Encroachment Appeal – 86 Kilbarry Road – Fence and Bollards

Date: June 19, 2025

From: Director, Permits and Enforcement, Transportation Services

Attachment 2: Elevation Details of Proposed Encroachment – 86 Kilbarry Rd

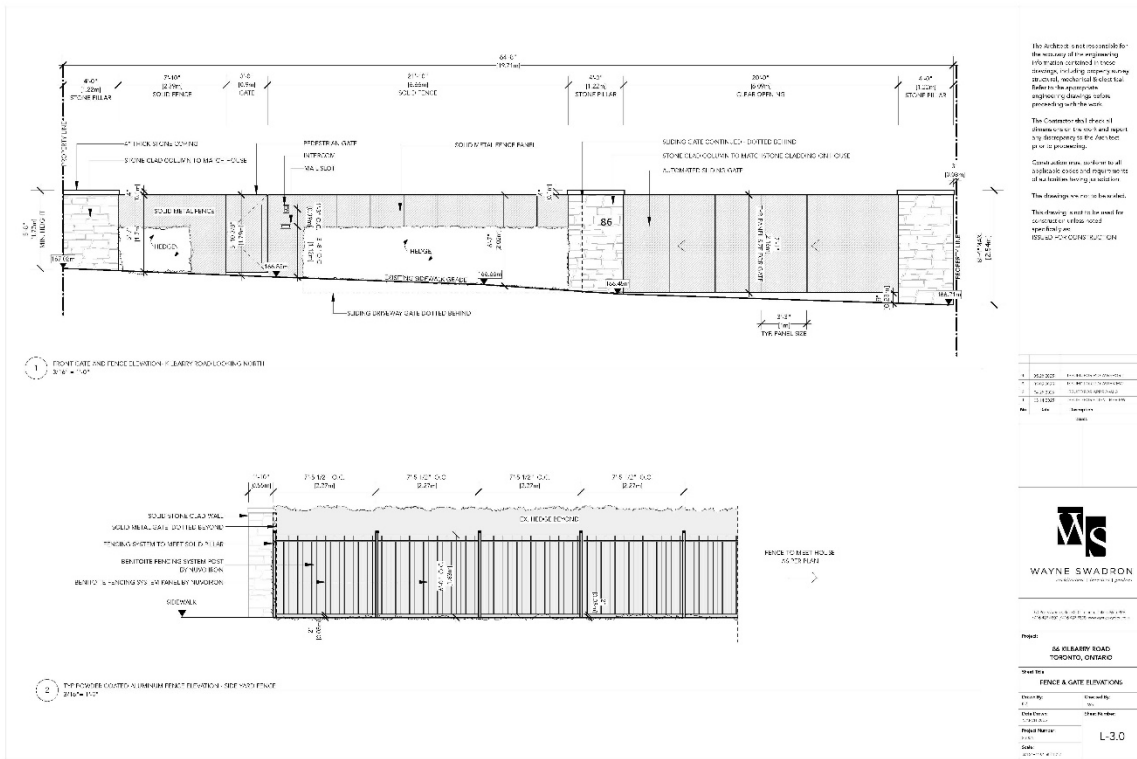
- The proposed aluminum metal fence which includes three stone pillars, an automated sliding driveway gate, and an electrical pedestrian gate will be built to a maximum height of 2.54 metres, which contravenes Chapter 743 article 743-34A.(2)(a) "A fence located within a street can be built to a maximum height of 1.20 metres for that portion of the fence fronting the property, and 1.80 metres for any fence located in the flankage of the property, provided that to ensure unobstructed driver and pedestrian sight lines"

- The proposed aluminum metal fence which includes three stone pillars, an automated sliding driveway gate, and an electrical pedestrian gate will be built to a maximum height of 2.54 metres, which contravenes Chapter 743 article 743-34A.(2)(a)[2] requirement that "No solid screen fence, privacy fence, railing, bollard, arbour, pergola, ornamental or retaining wall located within three metres of a driveway that is adjacent a sidewalk, or the travelled surface of any road without curbs, shall exceed a height of one metre, measured from the grade of the adjoining driveway".

Transportation Services staff have reviewed the application and determined that the proposed fence causes a sightline concern at the property's driveway access and only provides a 1.0 metre setback instead of Chapter 743's 3.0 metre requirement. The proposed fence dimensions and requirements are outside what is considered normal. As such, the sightline created cannot be mitigated without reducing the height, which would compromise the intended security function the applicant is seeking. As proposed, the fence would obstruct sightlines for pedestrians using the sidewalk and for vehicles exiting the property and vehicles traveling along Kilbarry Road.

As a result, Transportation Services does not recommend Toronto and East York Community Council authorize the encroachment appeal application and direct the encroachment be removed and/or modified to comply with Toronto Municipal Code Chapter 743.

Attachment 5: Photos of Existing Conditions and Encroachment – 86 Kilbarry Road – June 5, 2025

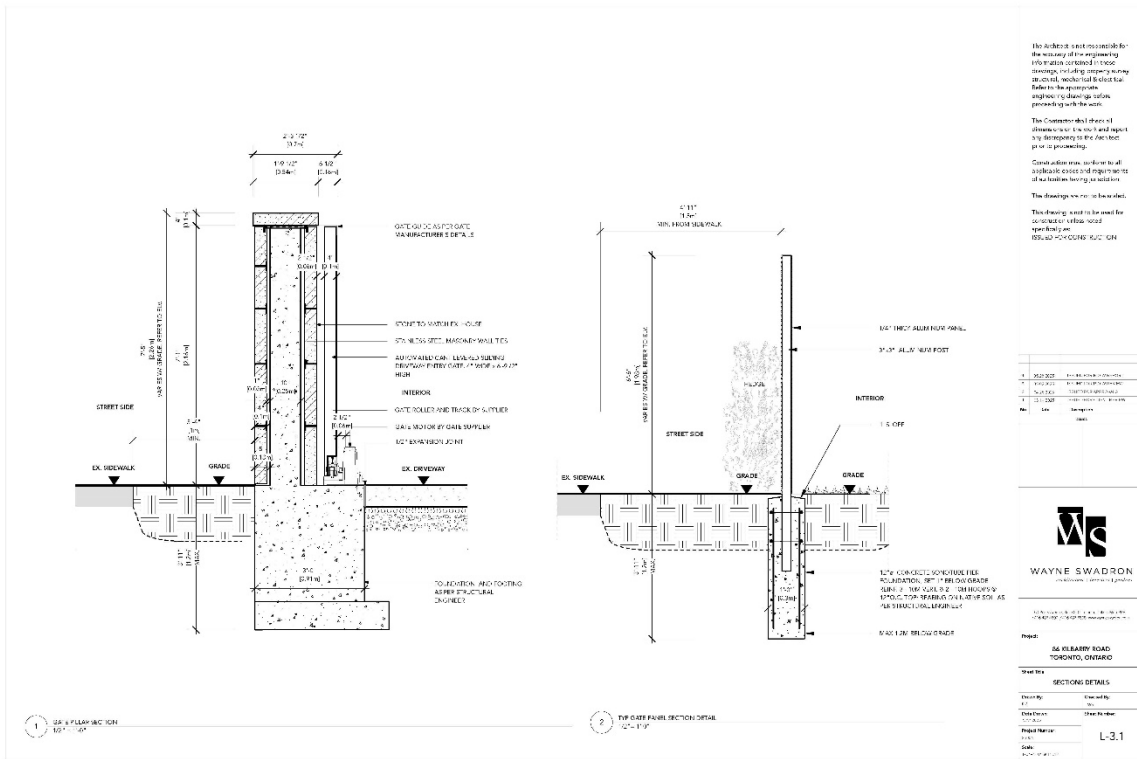
- The installed four steel automated retractable bollards are installed at a setback of 0.25 metres from the back of the sidewalk, which contravenes Chapter 743 article 743-31E.(2) "Unless otherwise specified in this chapter, no encroachments other

- The installed four steel automated retractable bollards are installed at a depth of 1.40 metres, which contravenes Chapter 743 article 743-31E.(2)(b) "The footings for the fence, railing, bollard, arbour, pergola, ornamental or retaining wall that are located within the street shall not exceed a depth of 1.20 metres measured from the surface of the adjoining boulevard"
